Bulletin no. SPB023A

Subject: MRC-135AS, URC-125/140AS

Reference: OLP compressor sensor (Overload)

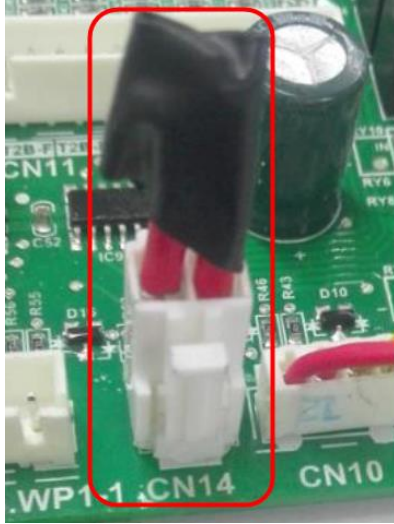
As part of Actron Air's continuous product improvements, from January 2018, our 13 kW Multi Condenser (MRC-135AS) and 12.5kW and 14kW Universal Condenser now come with a factory-fitted Overload Protection Sensor (OLP). With this improvement, there is now a plug base connection on our new outdoor boards that the OLP sensor will plug into. Due to this, all replacement spare parts of this outdoor board will now come with this additional plug base. In instances where an outdoor board is replaced on a unit manufactured prior to January 2018, a 'P2' fault code will be generated.

A jumper wire link, (part #MRC13528C) will now be fitted with the outdoor pcb/assy to ensure it can be installed to systems manufactured prior to January 2018, to ensure an error isn't generated. Refer to table 1.0 below for a reference on what part numbers will have the link wire fitted.

- If a pcb/assy is sent to the customer without the jumper wire link you can bridge the CN14 socket out temporarily & send the wire link MRC13528C individually.
- When a compressor is supplied as a spare part without the OLP wires fitted and has a new pcb assy (CN14 socket) the OLP sensor can be by-passed by cutting and joining the wires installed into the CN14 socket.
